Our Ref: 24319

**Response to Coal Authority Comments Regarding Site at Highstone Lane,
Ward Green, Barnsley**

**Ref No. 24319
 Highstone Lane,
 Worsbrough,
 Barnsley,
 S70 6SD**

**Figure 1:
 INTERPRETATION OF
 ROTARY DRILLING
 (NGR 434830,404550)**

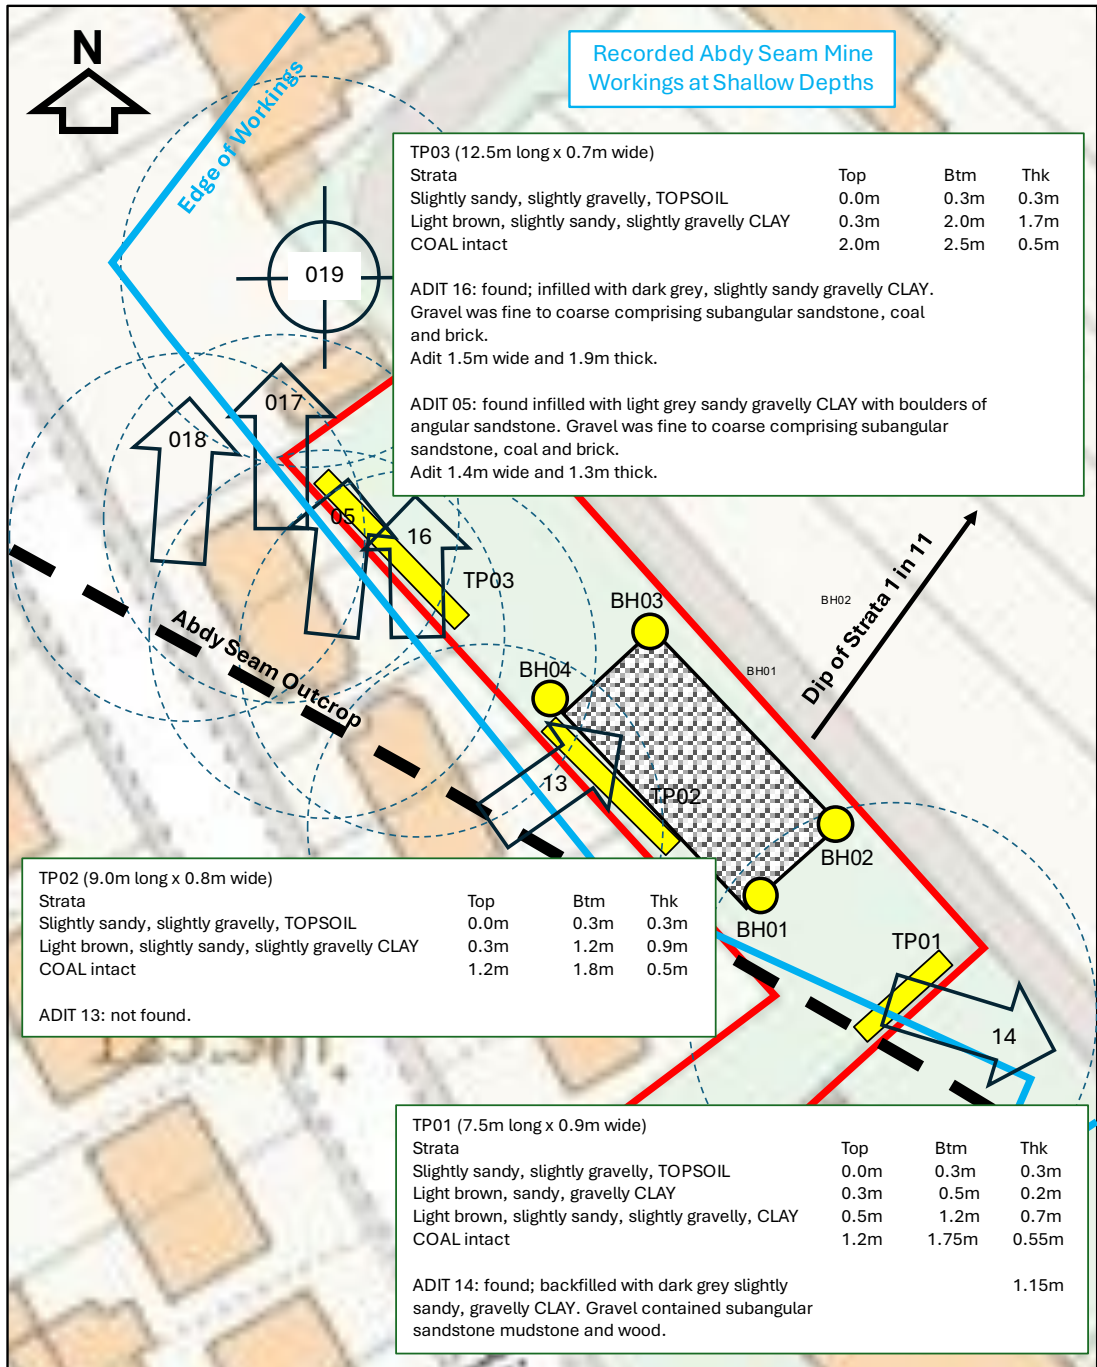
The role of Phase 2 site investigation is to clarify a mining risk previously identified in a Phase 1 desk study and either mitigate it or to recommend further investigations. Phase 2 rotary drilling and machine excavated trial pitting were undertaken under a MRA licence (No.29438) during March 2025 and are summarised in Figures 1 and 2. Site investigation proved the following:

- “Pillar and stall” type mine workings were present in the Abdy coal seam at shallow depths (1.20m to 2.70m, to top of seam). SEL reported that it was “*unable to mitigate the risk without further remedial work, Section 6.1.*”
- Trial pitting was undertaken to identify the locations of shafts that directly affected the site development. SEL reported that “*the risk from adits 434404-05, 434404-13, 434404-14 and 434404-16 cannot be mitigated without further works, Section 6.1.*”

With respect to the shallow mine workings in the Abdy seam, Phase 2 investigations proved that the stability ratios between the surface and the Abdy seam were substantially less than 10:1, which indicates building on these workings would be unstable without treatment.

SEL have recommended drilling and grouting to prove and stabilise the workings. Boreholes would initially be drilled on a 6.00m centred base grid to 1m below the coal seam/workings and grouted. Where grout uptake is high, the grid would be augmented by extra drilling/grouting at intermediary locations until the workings are sealed (3.00m spacing and 1.50m spacing if grout uptake continues to be high).

INTERPRETATION OF TRIAL PITS

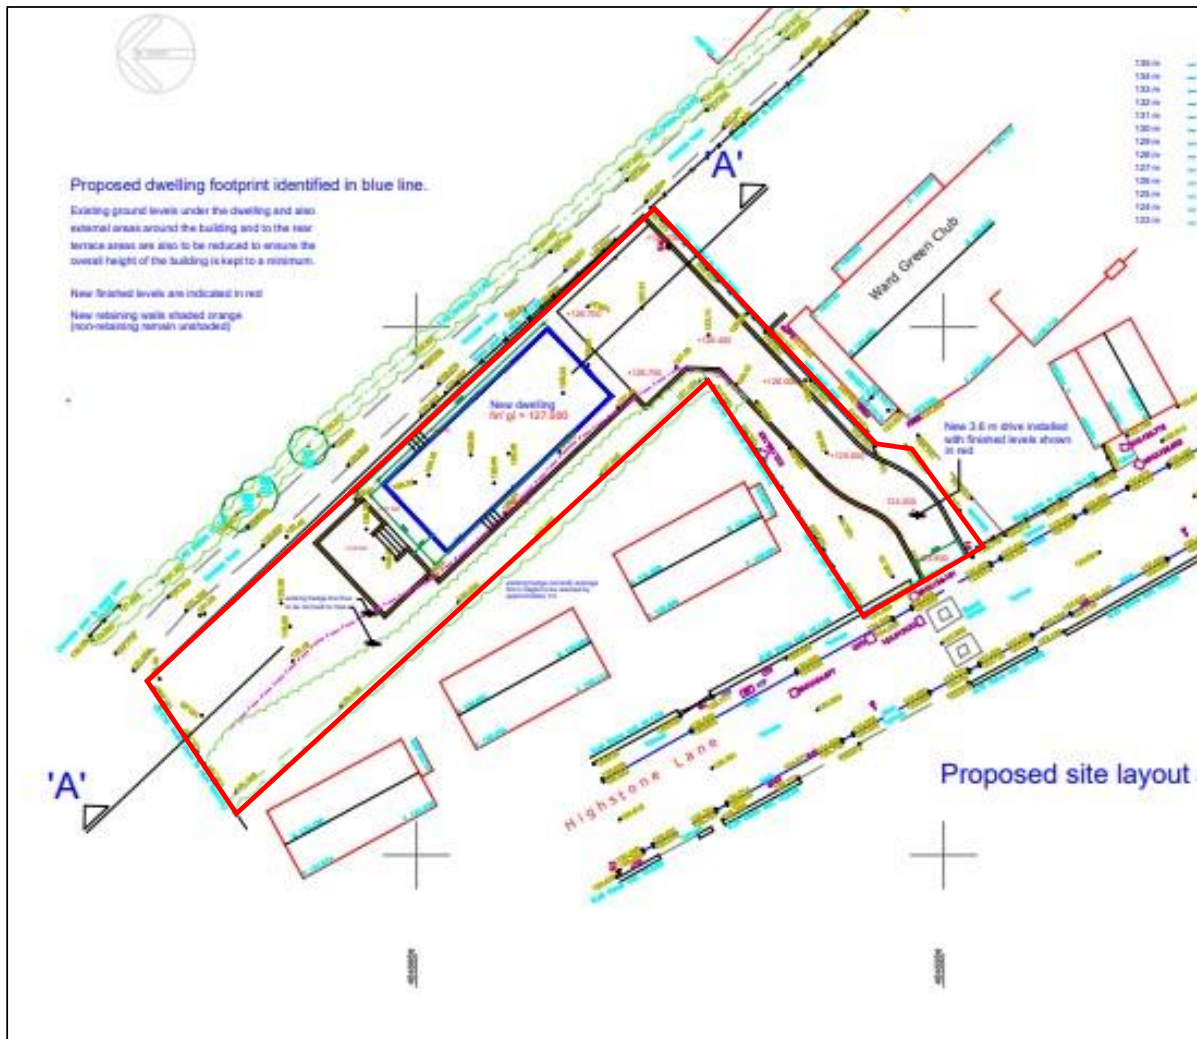
With respect to adit 434404-13, (located beneath the proposed building), trial pit 02 proved coal at a depth of 1.2m. The adit was not found. Phase 3 operations will need to prove the location, depth and direction of the adit and seal it as part of the stabilisation works. Further details regarding the drilling and grouting of the site will be provided in the Phase 3 treatment works, which to date have not been authorised. All works should be carried out under a MRA permit, in consultation with the MRA.

With respect to adit 434404-14, which is located at the south eastern margin of the site, trial pit 01 proved the adit 1.15m thick and backfilled with gravelly clay. As the risk has not been discounted, Phase 3 operations will need to mitigate the risk in a similar manner to that described above.

RISK AREAS

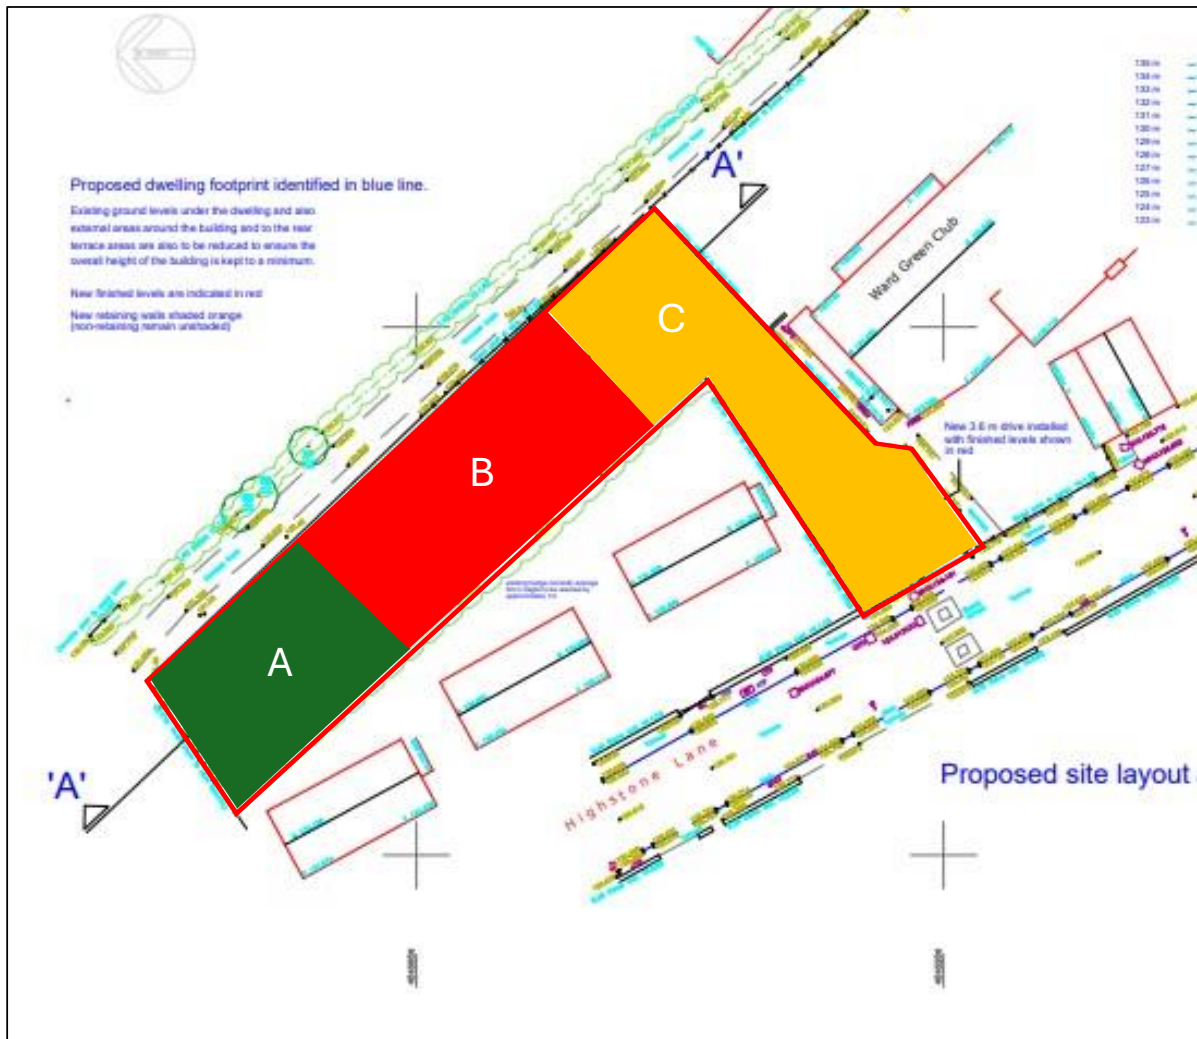
The client proposes to build a dwelling with associated facilities, as shown in Figures 3 and 4. With respect to mitigating the mining legacy risk, the MRA identifies some sites are exempt by nature of their development. SEL believes the proposed development consists of three areas:

- North western area: SEL understand that this area will form the garden of the property. As such, the development will entail minimal groundworks and no substantial foundations. SEL consider it is reasonable to assess this area as exempt, provided the development is undertaken as currently envisaged.

- Central area: consists of the new property and includes an area of terracing immediately west of the property. SEL considers that this area will require drilling and grouting to stabilise this part of the development. Grouting should be limited to an area 5.00m beyond the footprint of the proposed property (including the terrace), where it is feasible to do so.

- South eastern area: SEL understand this area comprises the access drive to the property and will include the construction of a small wall. The MRA on line guidelines for planning applications consider fences, walls and gates to be exempt due to the minimal disturbance of ground. With respect to the drive, SEL understand that due to the nature of the topography, there will be a small amount of surface scraping to ameliorate the access and will comprise a sealed surface/resin. The MRA do not define mitigation requirements for access drives to domestic houses in their guidelines. SEL recommend the client provides the MRA with development details in this area so they can provide guidance prior to Phase 3 works commencing.

Area A: Garden area . No significant groundworks, no foundations.

Area B: New property and terrace area. Significant groundworks/foundations required. Drilling/grouting recommended to a minimum of 5m beyond property, where possible.

Area C: Access drive including retaining wall. Small amount of surface scraping required due to nature of topography.
